Bid Addendum 05

Project: Maritime Museum Education Center,
Beaufort, NC – Construction Phase Services

Date: August 2, 2024

SCO#: 24-27956-01A

SHEET
BUILDING SECTIONS

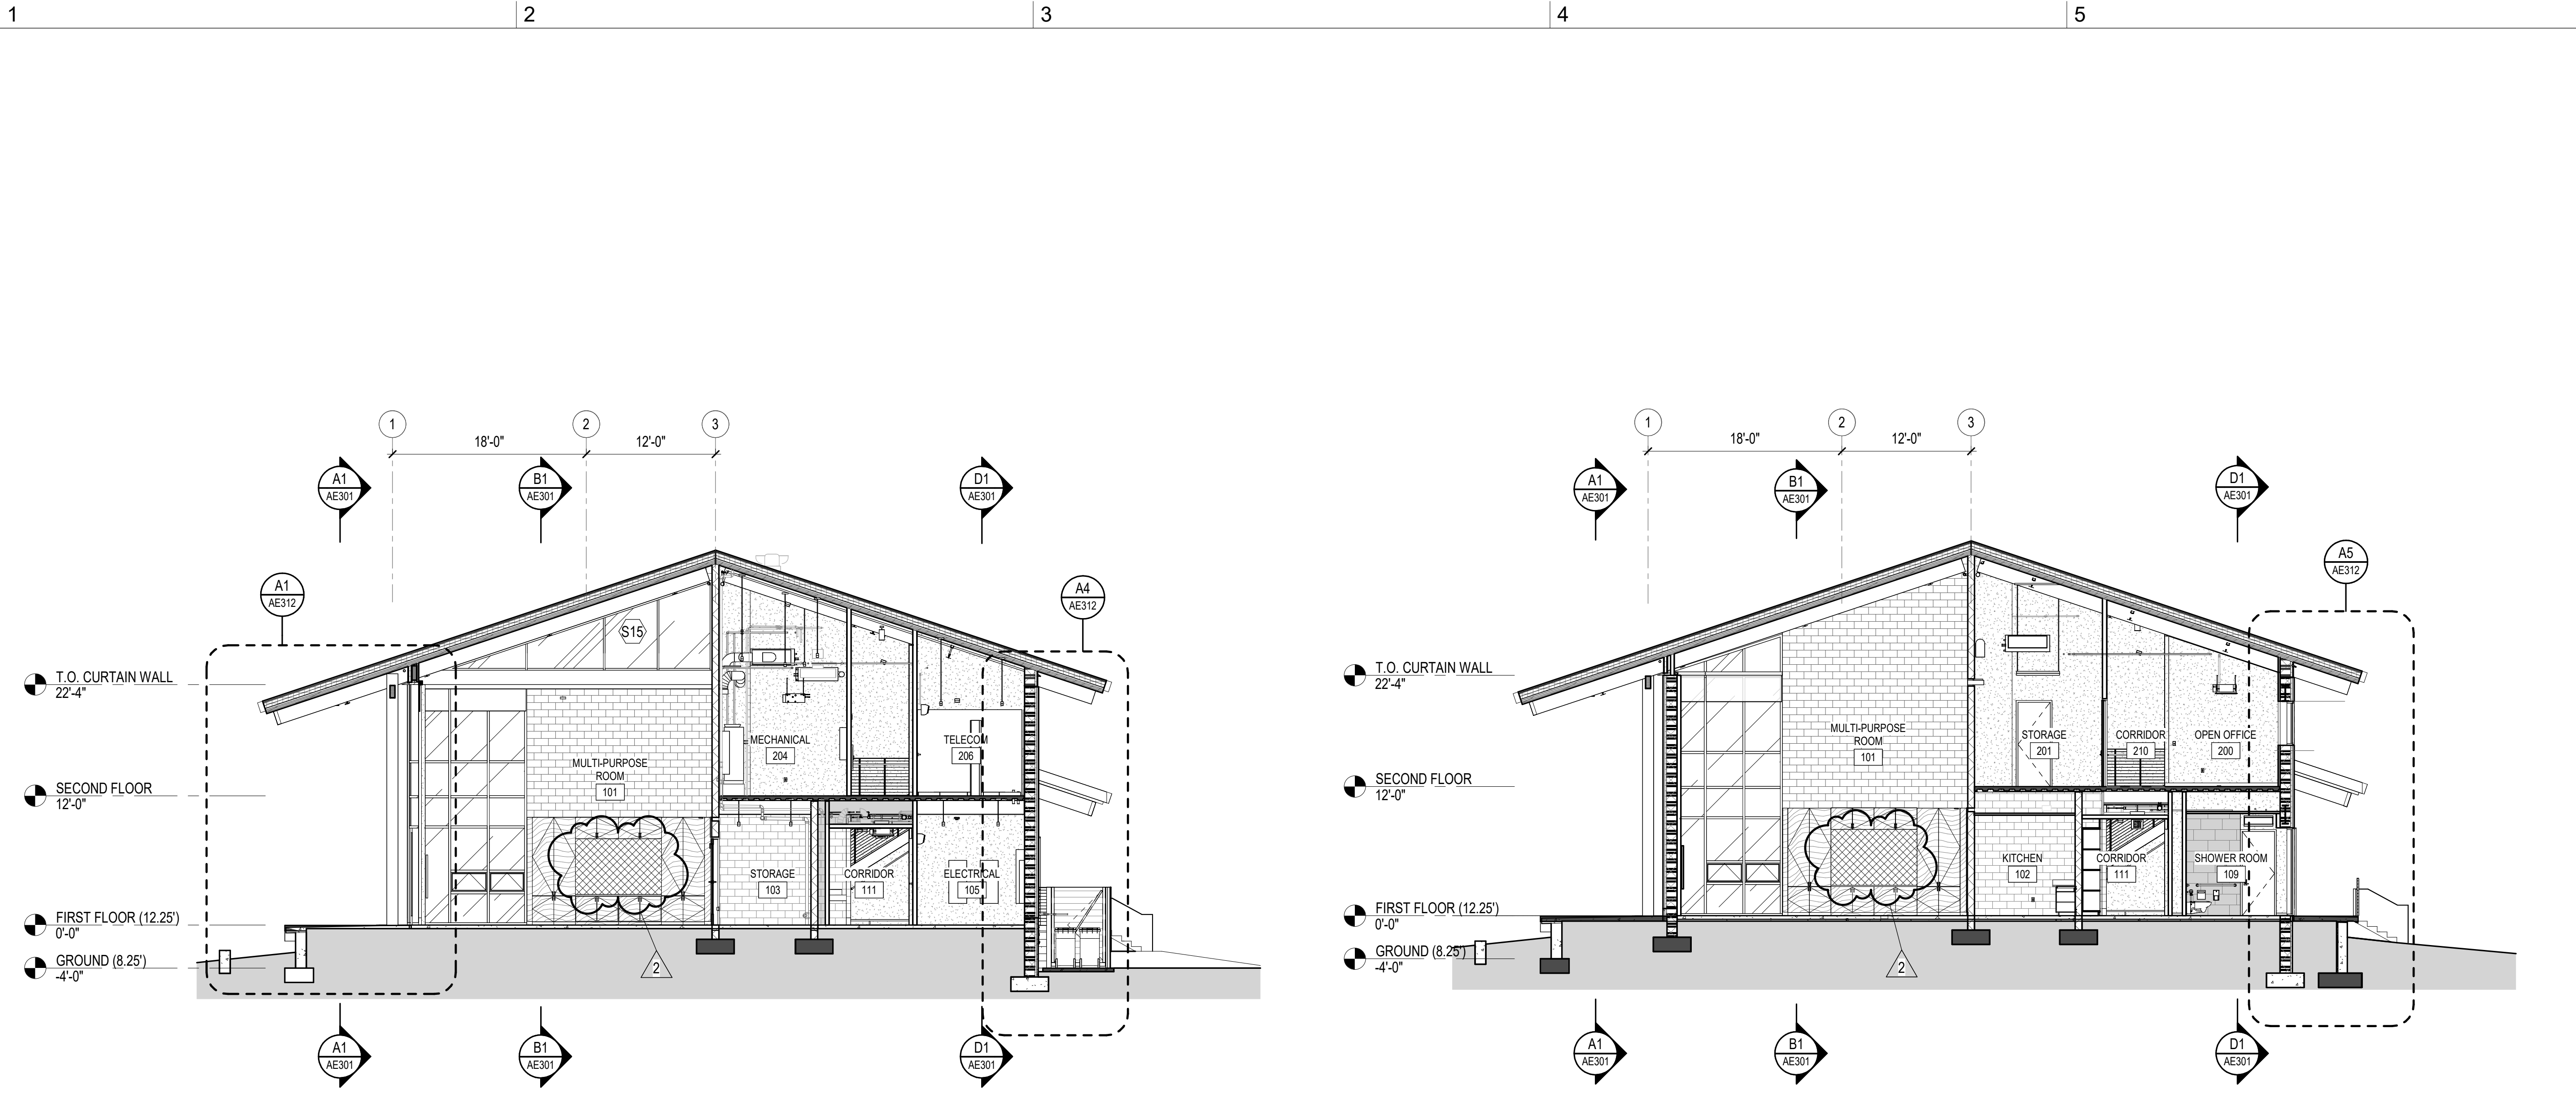
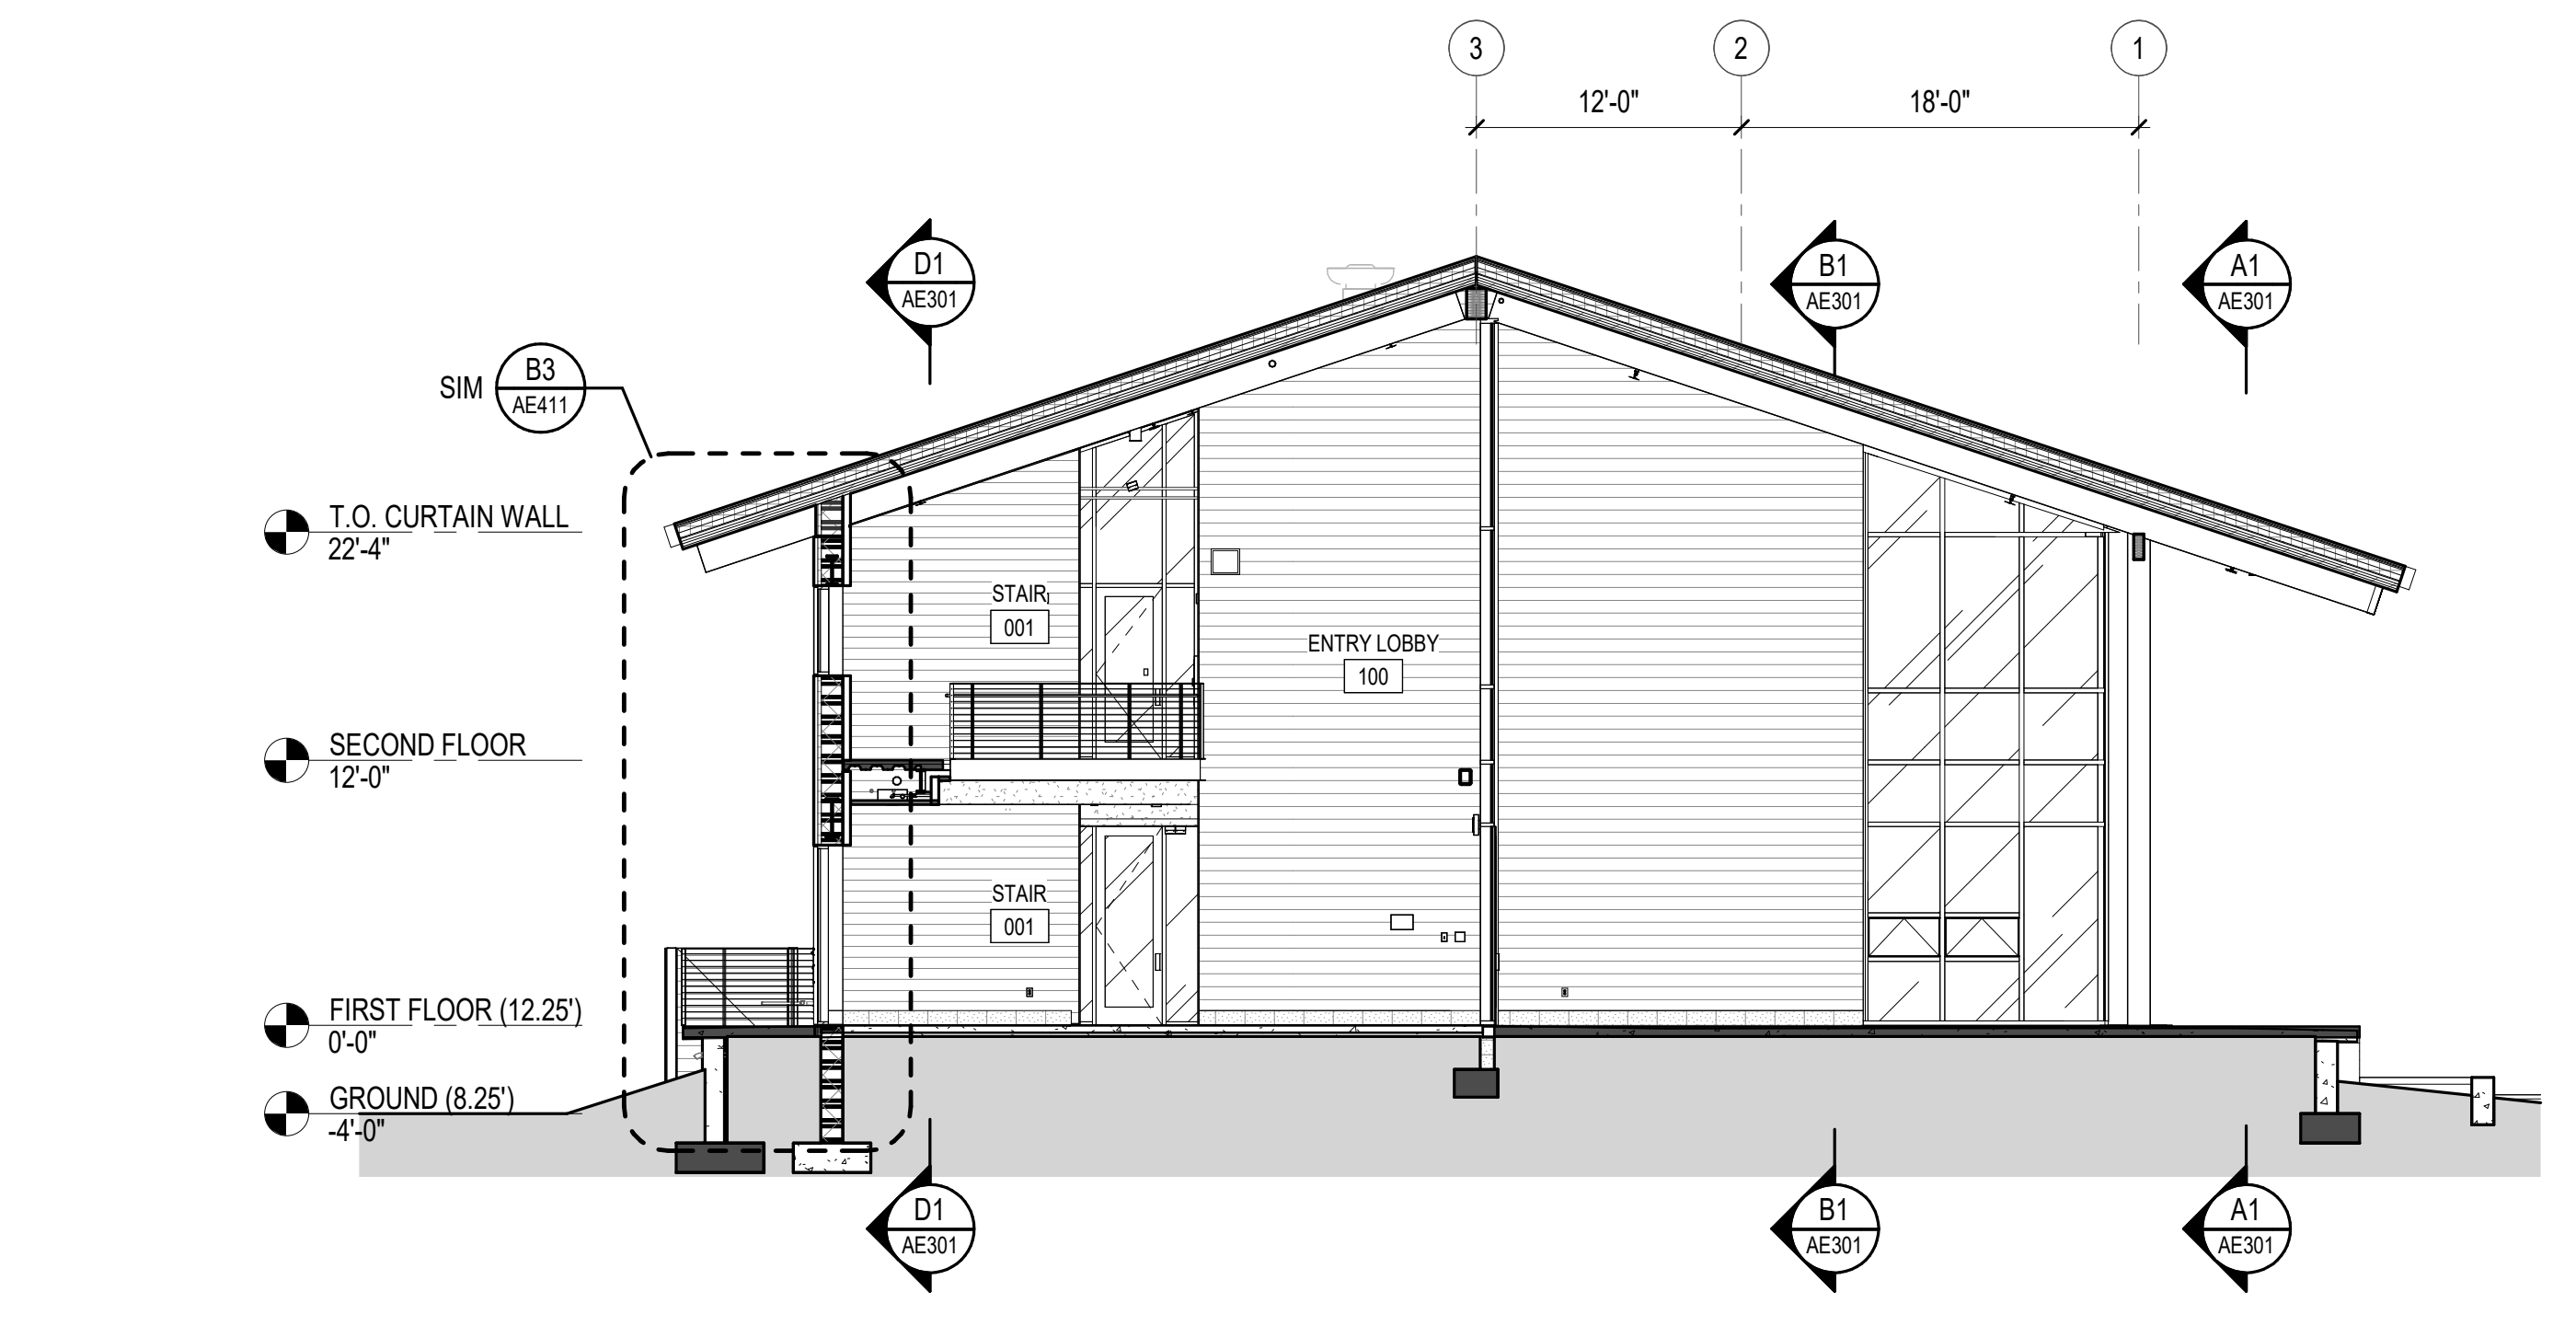
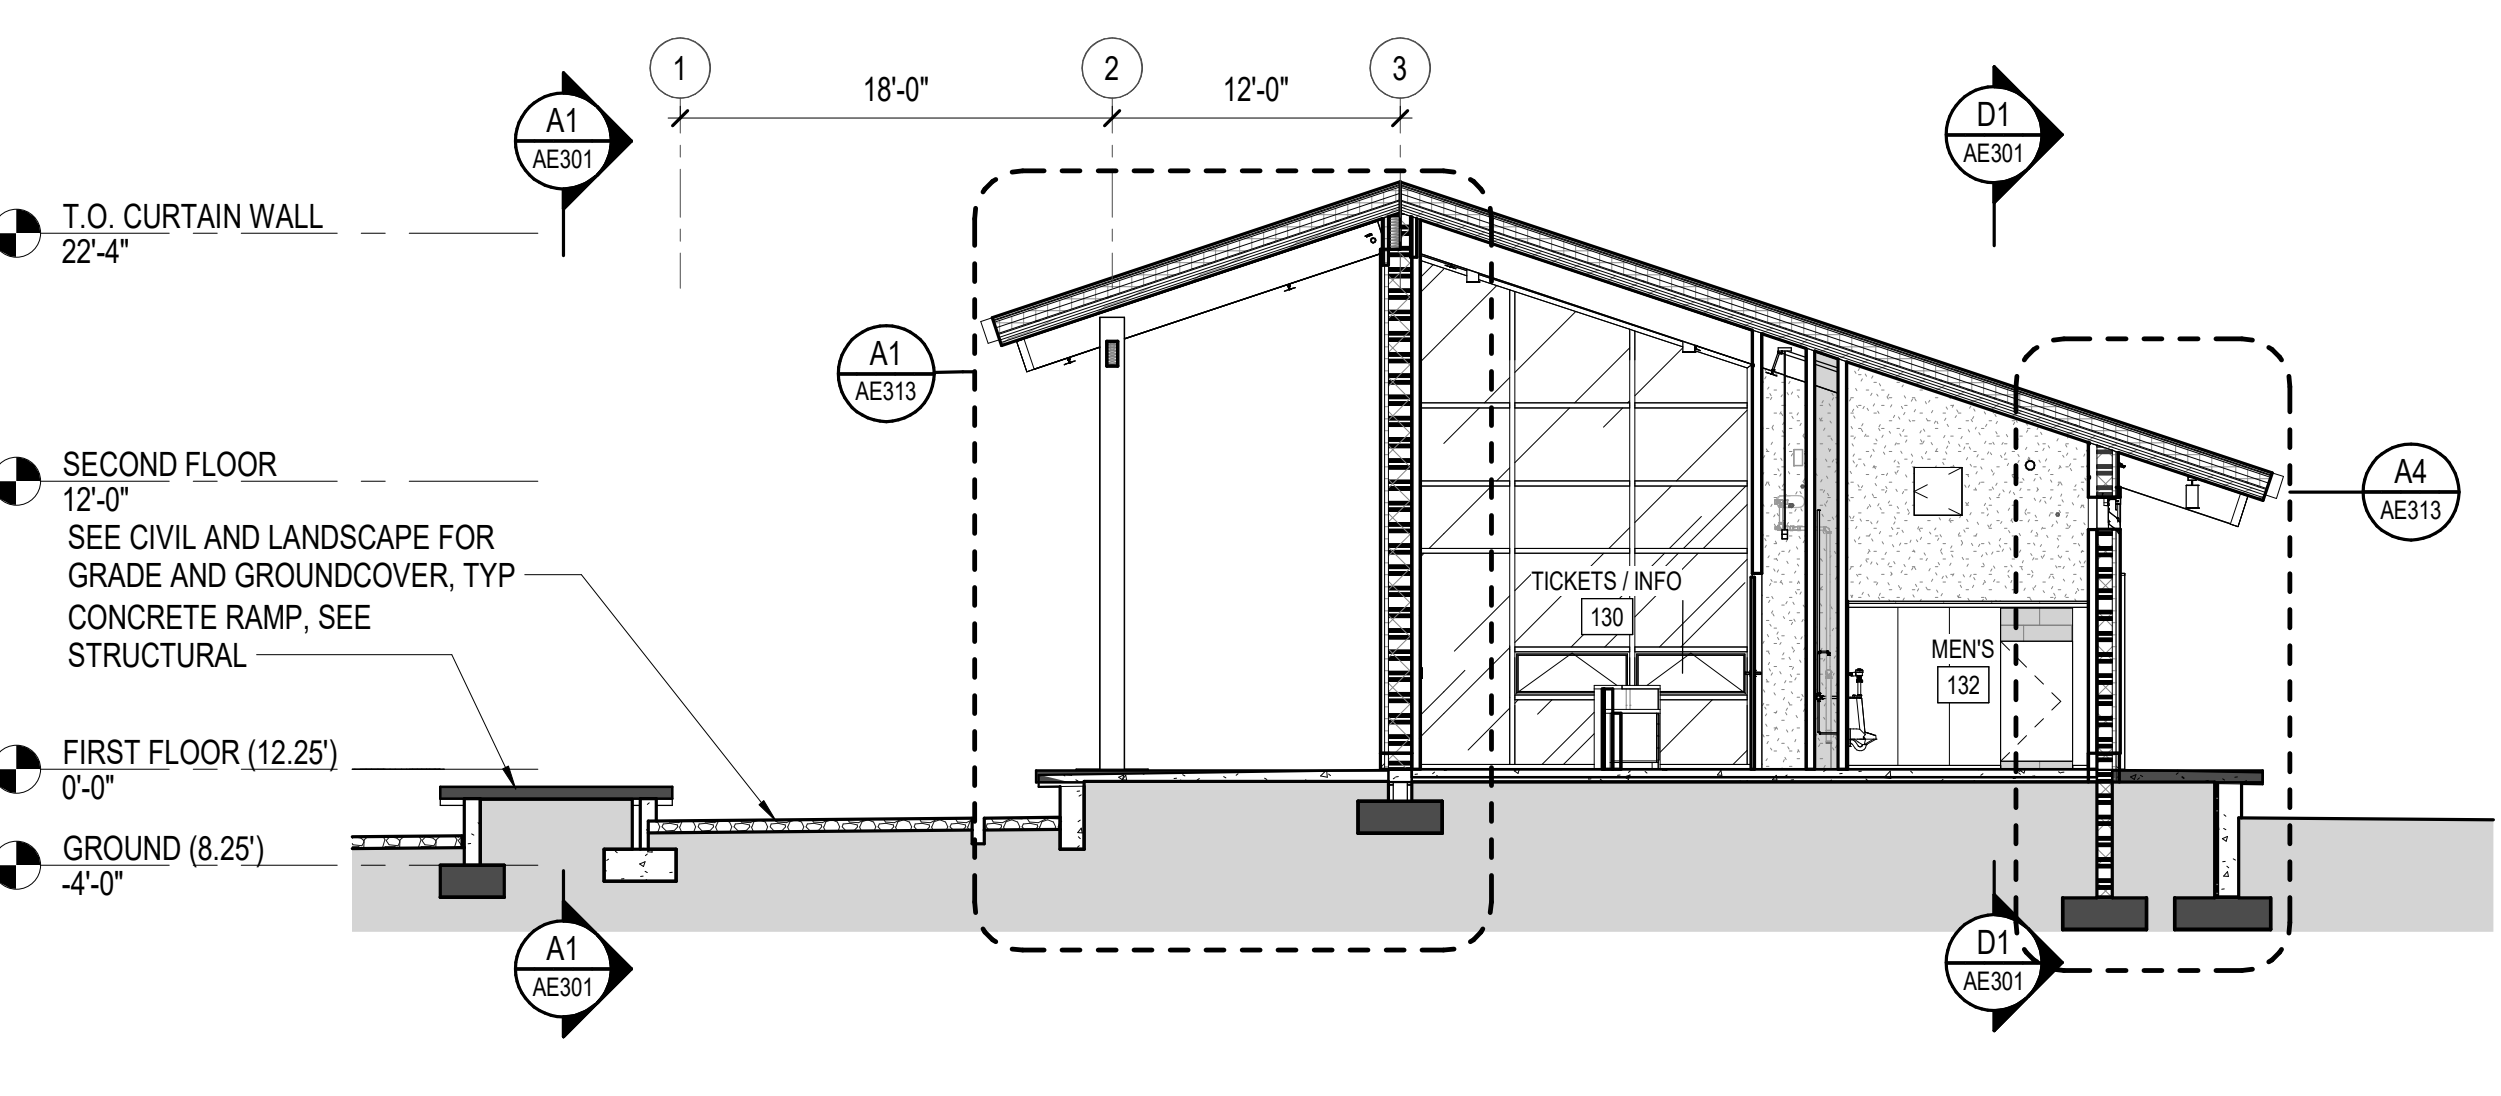
16. Sheet L4.00:
 - a. Detail 8 Grasspave2 Details has been added.
17. Sheet L4.00:
 - a. Detail 8 Grasspave2 Details has been added.
18. Sheet AE302
 - a. Sound Absorbing Wall callout has been added.
